**Robatel Technologies, LLC
RT-100 RAI Meeting
July 22, 2013**

RAI Dated March 28, 2013
TAC No. L24686
Docket No. 71-9365

RAI 2-2 Response (cont)

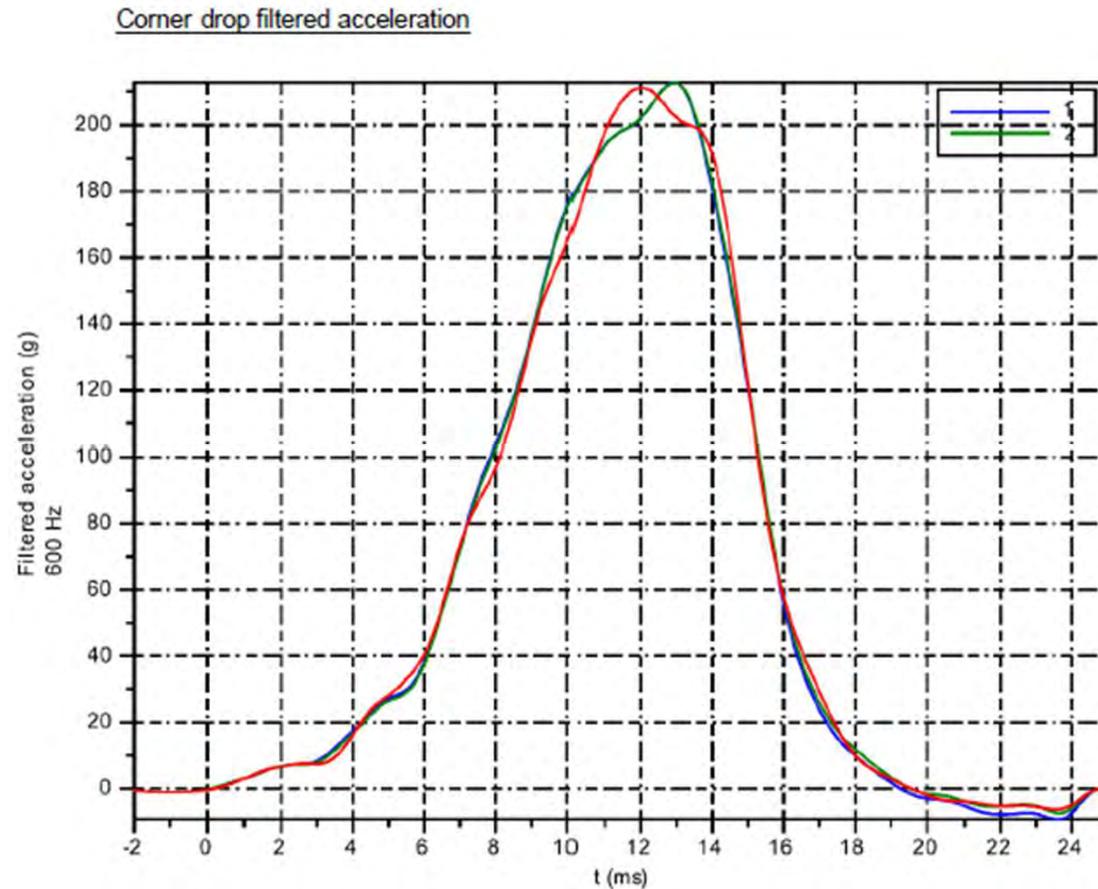
Provide further justification that explains how and why the foam crush strength data, in the “densification region” for strains beyond 60%, is used. This is a follow-up to RSI 2.2.

Explain how lock-up is considered and evaluated in the analysis. In response to RSI 2.2, the applicant indicated that the extrapolated values used are considered to be conservative and yielded a conservative deceleration value when compared to the drop test results. In addition to this justification, also provide an explanation of why a deviation from the manufacturer’s recommended properties is required and appropriate. This deviation may be important in the analytical effort that considers variations in the package design that were not present in the scale model drop test.

- ▶ RT-100 3/10th Scale Model Corner Drop Test results demonstrate that the impact limiter foam does not lock up and the cask body does not impact the ground
 - Foam temperature during test: 78°C

RAI 4-3 Response

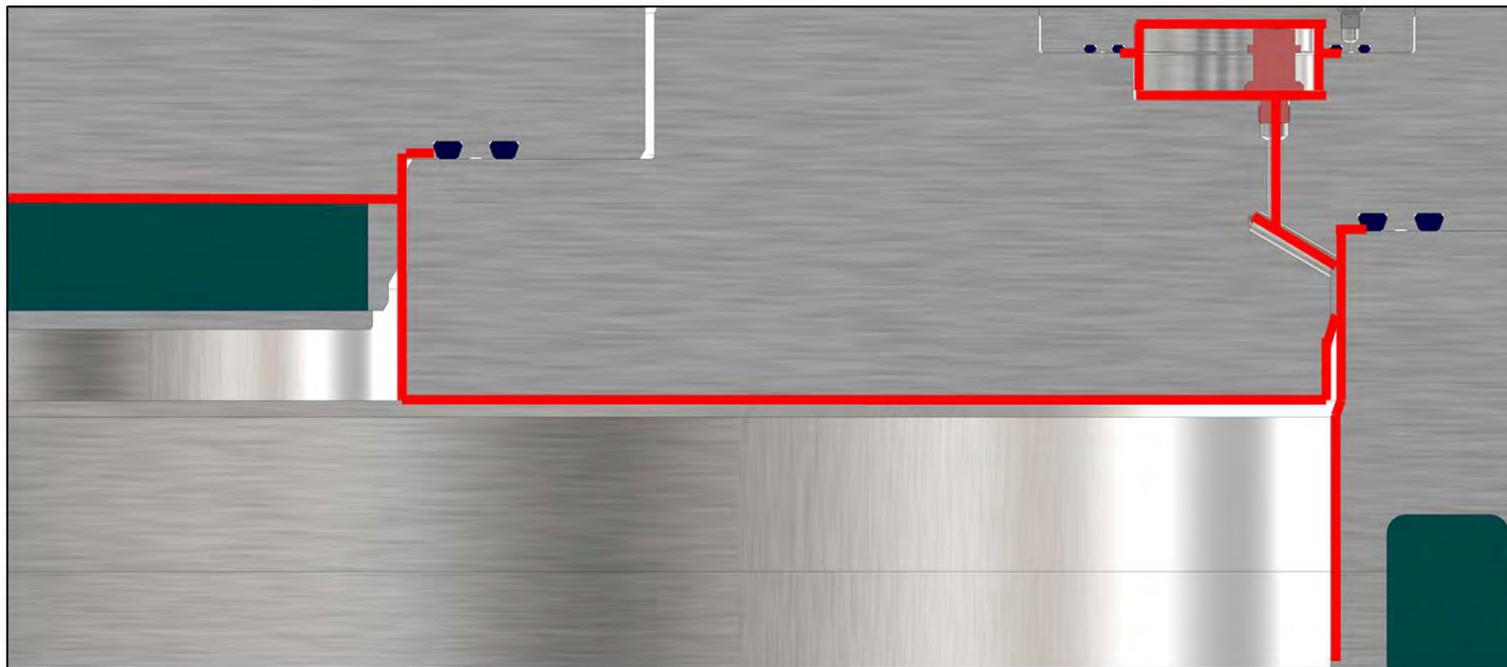
Provide a clearer picture and description of the containment boundary; the image and red line in Figures 4.1.2-1 and 4.1.2-2 on page 4-3 of the application do not clearly show the extent of the containment boundary in the upper right hand side figure.

The resolution of the line and image in Figures 4.1.2-1 and 4.1.2-2 is insufficient to clearly understand the containment boundary. A clearer image and description of the containment boundary should be provided.

- ▶ Figures 4.1.2-1 and 4.1.2-2 are being replaced by higher resolution pictures to provide a better illustration of the containment boundary

RAI 4-7 Response (cont)

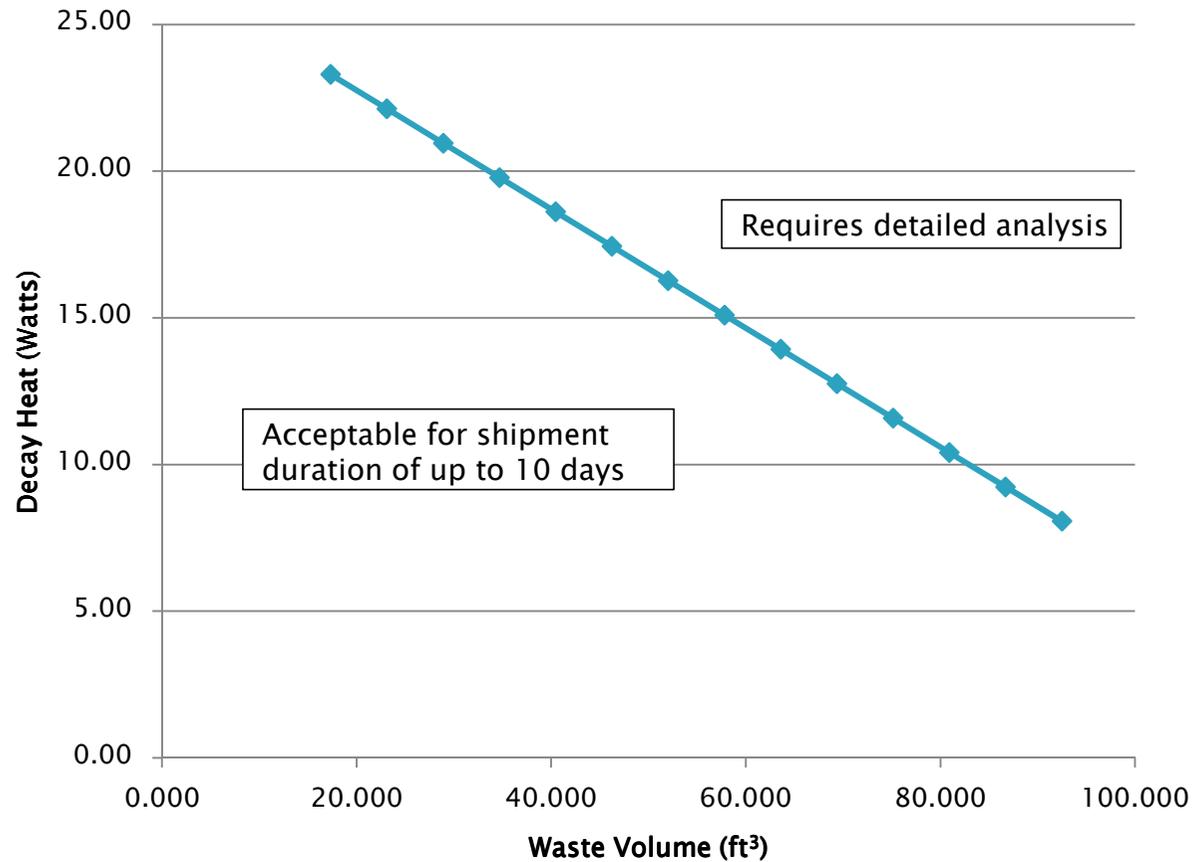
Justify that combustible gases generated in the package during the shipping period do not exceed 5%, by volume, of the free gas volume.

Section 1.2.2.6 states that the shipper must ensure that the hydrogen concentration within the container will be below 5%, by volume. In addition, page 1–8 states that the moisture content is limited to no more than 1% free water by volume. A bounding calculation of combustible gases that could form, based on the approved contents with their respective alphas, betas, etc., should be provided.

- ▶ Using the equation on the previous slide, the decay heat limit versus waste volume for a specific transport time (50% of gas generation time) and hydrogen buildup limit of 5.0 percent mole fraction can be determined
- ▶ The following slide provides a curve illustrating the waste volume as a function of decay heat that would result in the generation of the hydrogen buildup limit within 20 days
- ▶ If the waste volume and decay heat values for a cask fall below the curve, the load would not generate a flammable gas mixture within 20 days
- ▶ If the waste volume and decay heat values for a cask are above the curve, the load would generate a flammable gas mixture in less than 20 days

RAI 7-2 Response

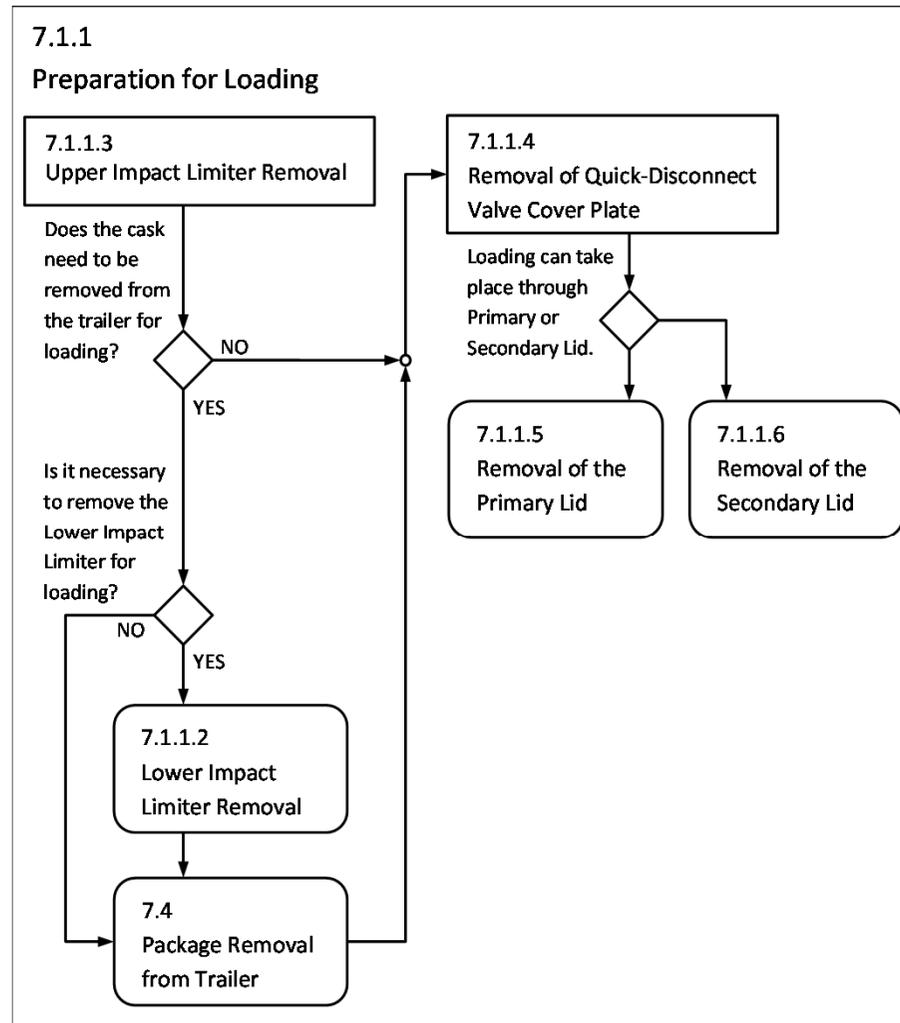
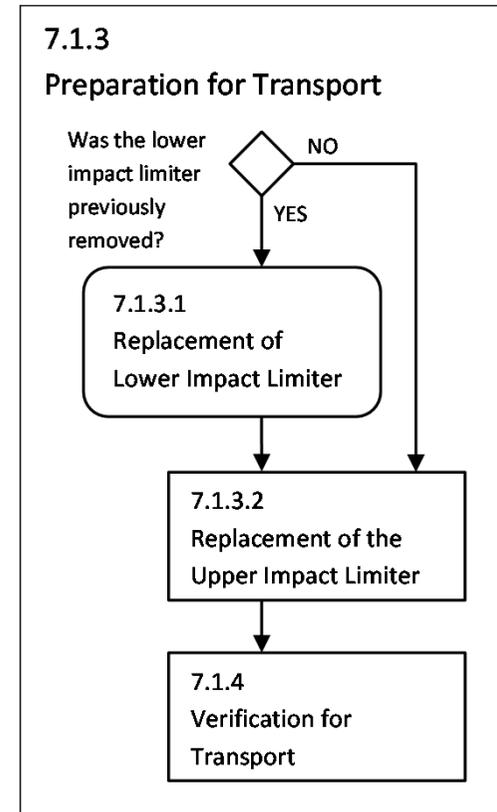
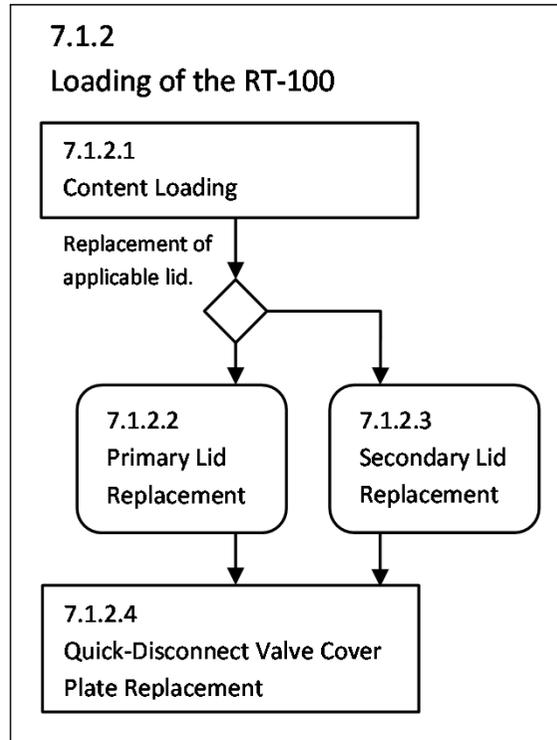
Clarify or modify the removal and replacement procedures for the impact limiters.

Section 7.1.1.1 "Package Removal from Trailer," directs to section 7.4 of the application. Staff notes that the first bullet on page 7-16 of the application states, "With or without the lower impact limiter attached, lift the RT-100 cask from the transport trailer (Figure 7.4-4)." Staff also notes that there is no reference to a specific set of procedures pertaining to the removal of the lower impact limiter in section 7.4 of the application.

- ▶ Section 7.1.1.2 and Section 7.1.1.3 of the SAR are being revised to state that the upper impact limiter must be removed prior to removal of the lower impact limiter
- ▶ Section 7.4 of the SAR is being revised to describe the option of lower impact limiter removal prior to removing the cask from the trailer
- ▶ Section 7.4 of the SAR will also be revised to describe the specific procedures for lower impact limiter removal
- ▶ The flow charts on the following slides illustrate the general sequence for cask operations
